ITEM 7. DEVELOPMENT APPLICATION: 331-337 KENT STREET SYDNEY**FILE NO: D/2013/1851****DEVELOPMENT APPLICATION NO: D/2013/1851****SUMMARY****Date of Submission:** 29 November 2013**Applicant:** Maville Bay Pty Ltd**Architect:** Cox Richardson**Owner:** Maville Bay Pty Ltd**Cost of Works:** \$100,892,454

Proposal Summary: Stage 1 DA for a proposed hotel/residential development with ground floor retail. The application seeks concept plan (stage 1) approval for the retention of the existing warehouse facade fronting Kent Street and a new building envelope with a maximum height of 80m and a maximum floor space ratio up to 11:1 (16,698m²). The proposal includes an upgrade of the existing Kent Street vehicle access and the provision of four basement parking levels.

Figure 13: Indicative Level 2 hotel layout

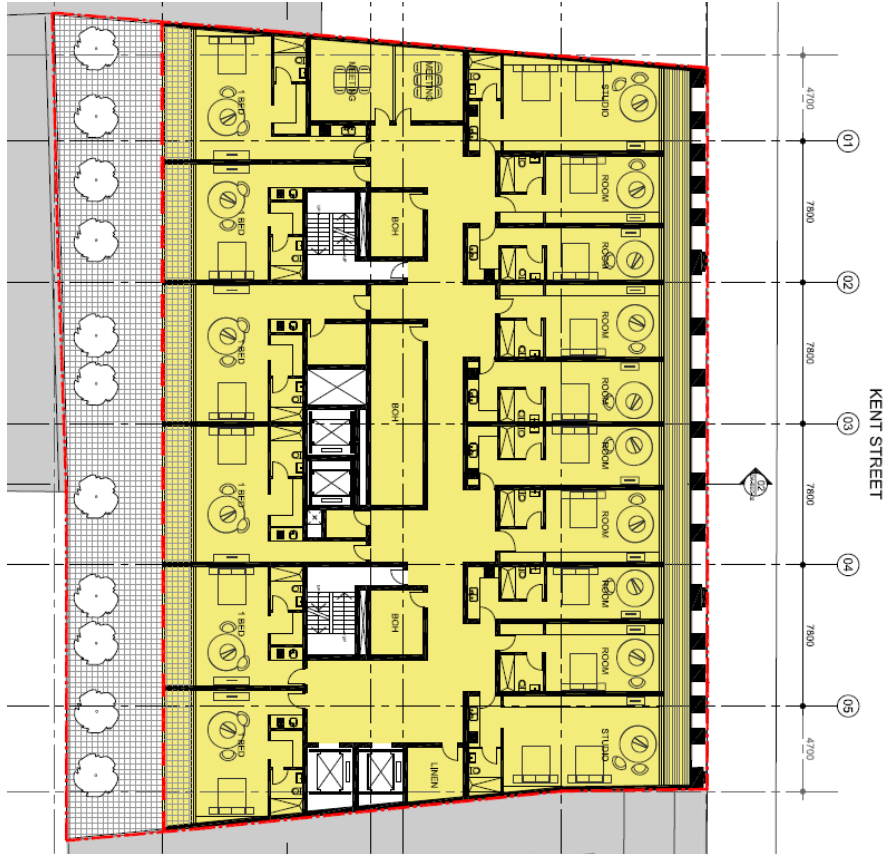
48. In principle no objection is raised to a hotel use in levels 1 to 14 of the proposed envelope. The indicative floor plans for level 4 to 14 (Figure 12 above) illustrate rooms which are more akin to serviced apartments rather than hotel rooms (for example the provision for kitchens and separate bedrooms).

50. Serviced apartments on the lower levels of a building would not be supported in the form illustrated in the indicative plans. It is highly unlikely that levels 4 to 14 could be reconfigured to provide an alternate serviced apartment layout which would provide an acceptable level of amenity. A recommended condition of consent identifies these levels as hotel rooms rather than serviced apartments.

Figure 16: Additional over shadowing of 161 Clarence Street at 2pm

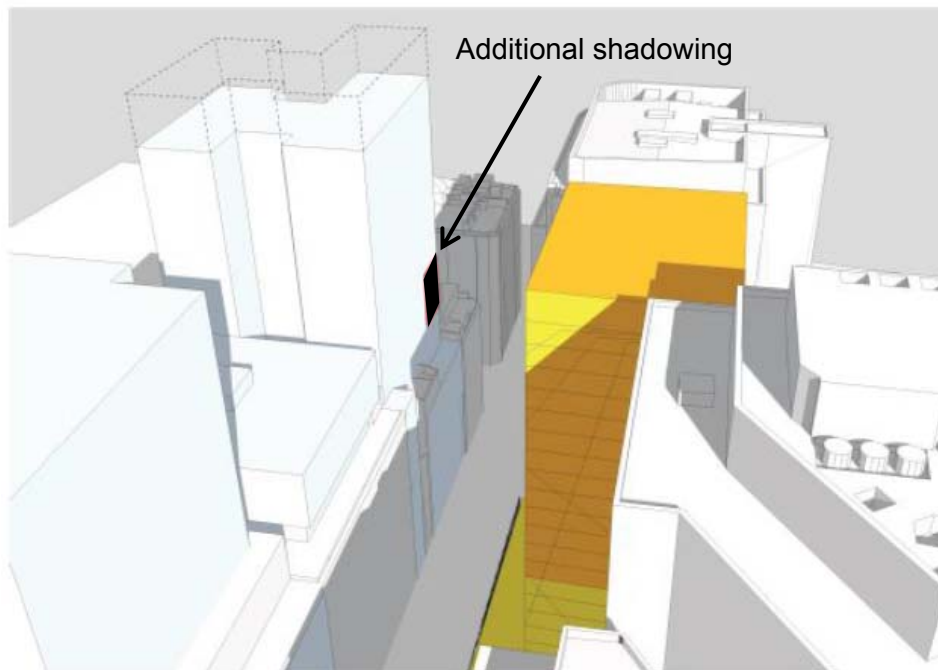
42. The most significant overshadowing impact of the proposal will be on 161-165 Clarence Street. The proposal results in additional overshadowing between 2pm and 3pm on 21 June. The impact of this overshadowing is particularly relevant given the recent approval for the redevelopment of this site to residential apartments. The figure below illustrates the additional overshadowing on 161 Clarence Street at 2pm and 3pm.

43. As demonstrated in the figure above, the additional overshadowing is minor and considered acceptable particularly given the CBD context of the site.

Figure 18: Indicative Level 2 hotel layout

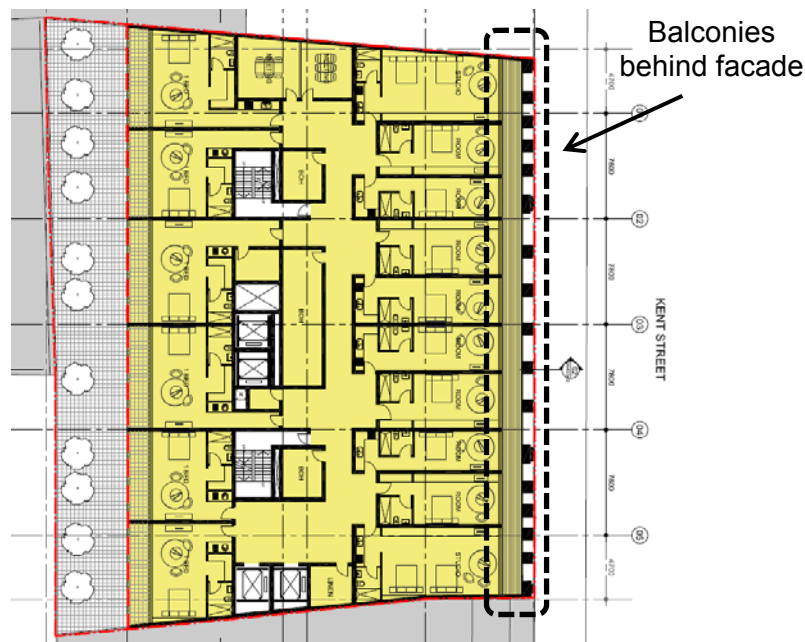
51. The indicative plans illustrate a more acceptable configuration for the hotel rooms within the podium (level 1 to 4), see figure below. However, any removal of the glazing from the warehouse facade to provide open balconies to these rooms would not be supported due to the impact on the retained facade's significance.
